RE: GEOTECHNICAL REVIEW OF MACRAES LOM DESIGN 2015

GEOTECHNICAL REVIEW
MACRAES LOM DESIGN 2015

PSM71-194R

LEGEND

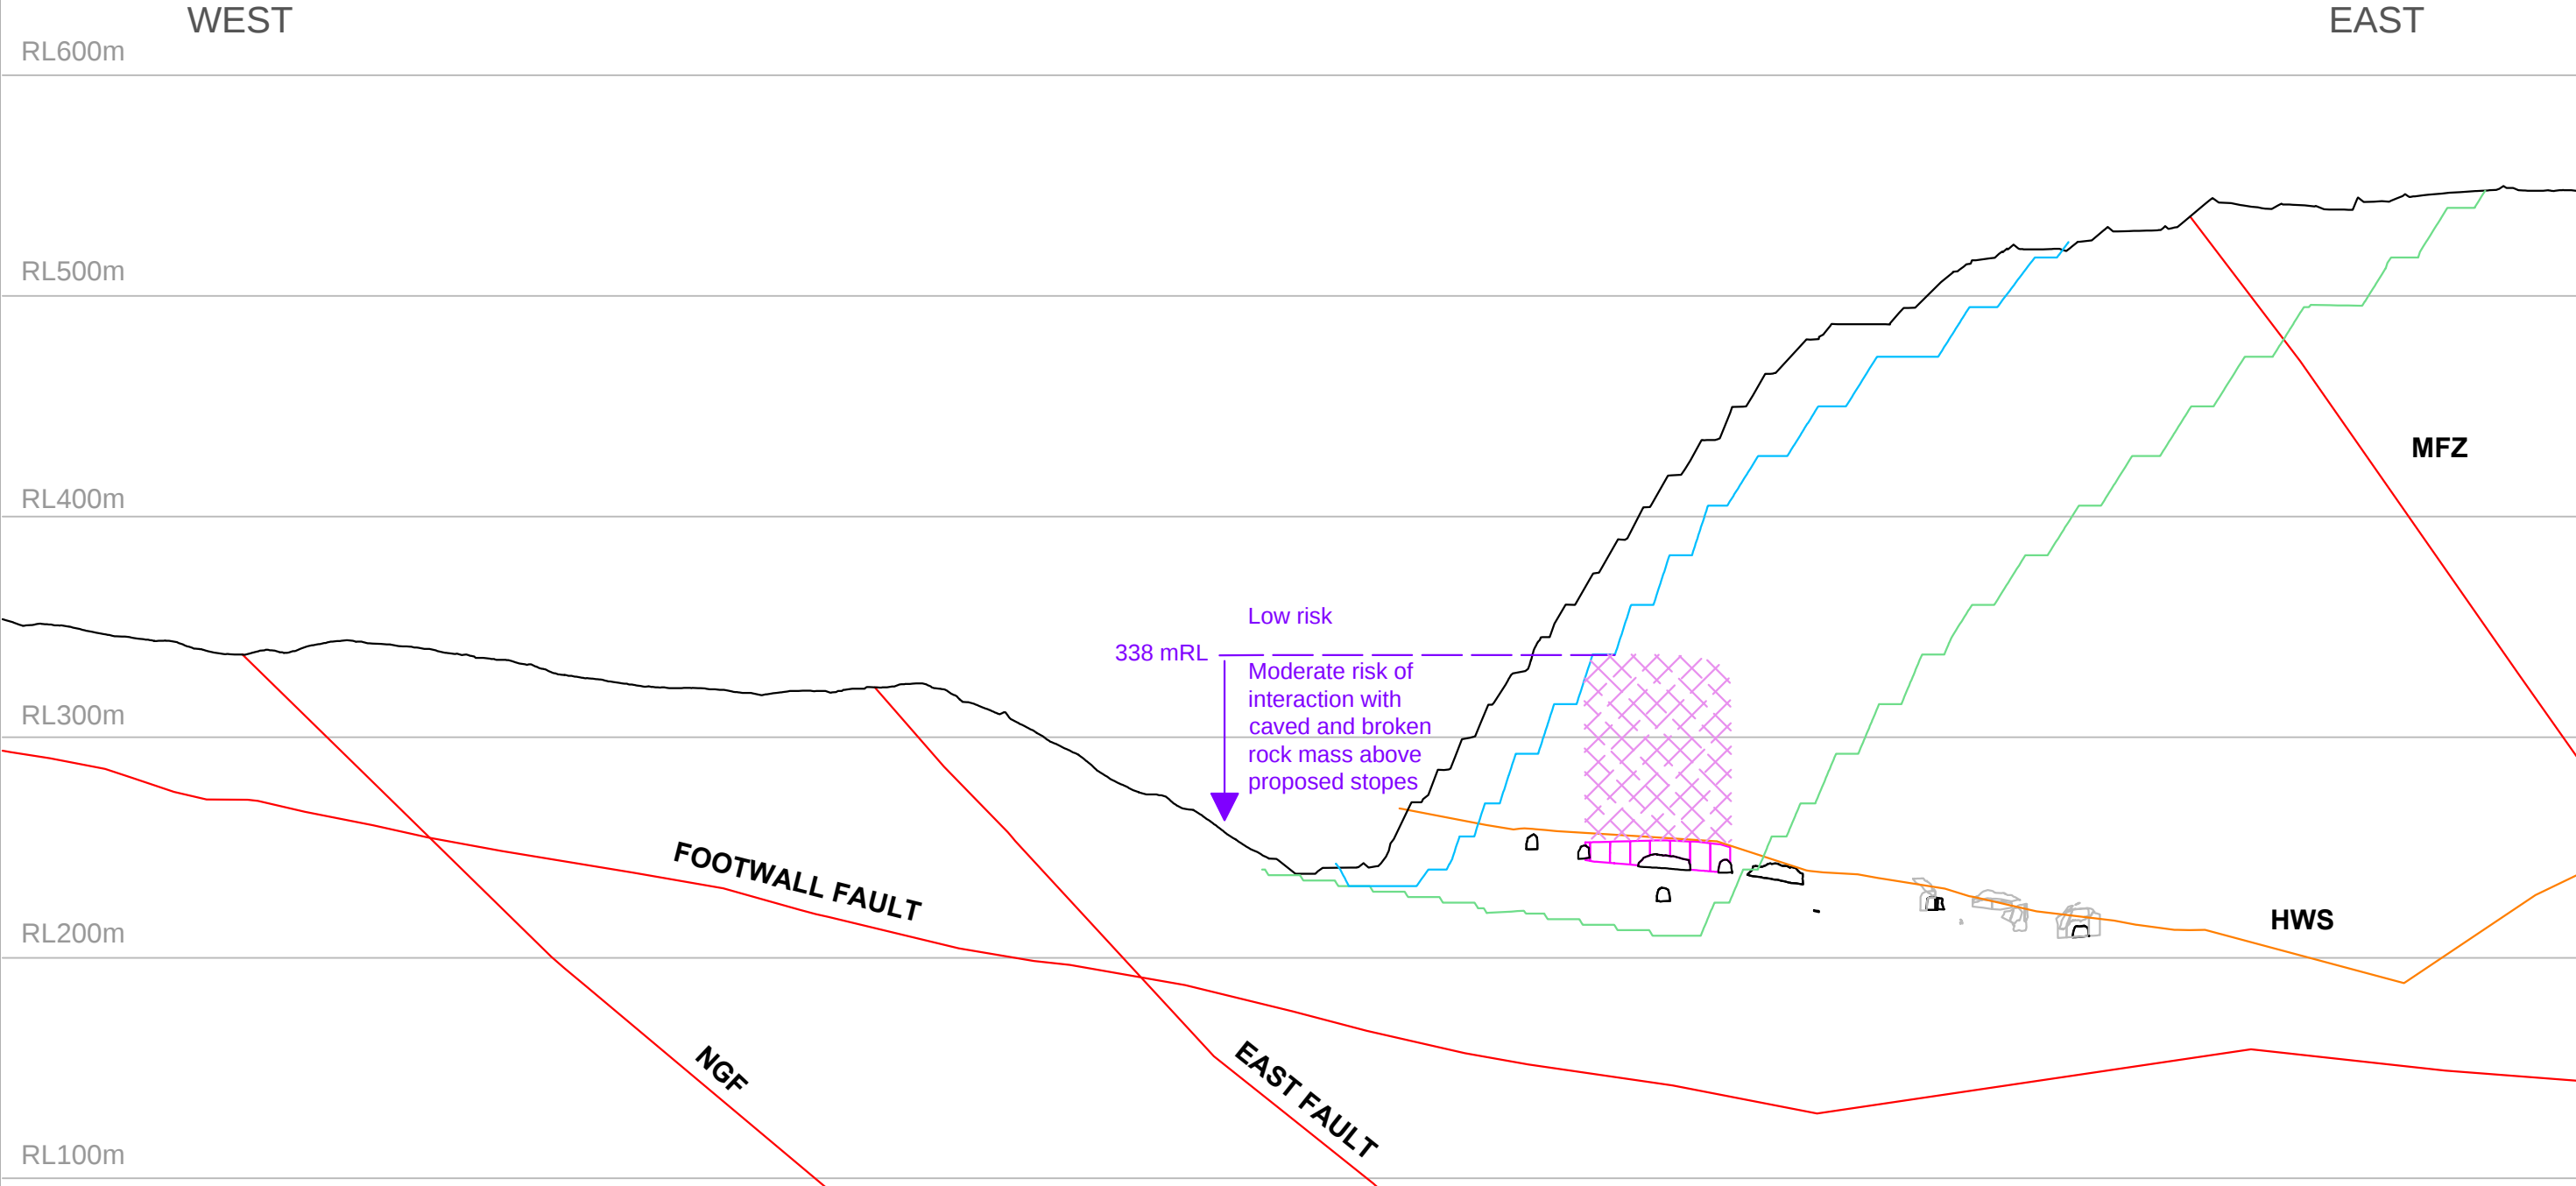
These areas are indicated in Figures 18 to 20.

TIMING OF FRIM STAGE 1	QUALITATIVE RISK
Before FRUG stopes	Low
After FRUG stopes	Moderate

There are no specific recommendations if the FRIM Stage 1 pit is mined before the FRUG stopes. If that is not the case, then OceanaGold will need to develop safe working procedures to mine above voids and broken or caved rock mass. Suggestions regarding probing etc. are provided in Reference 5.
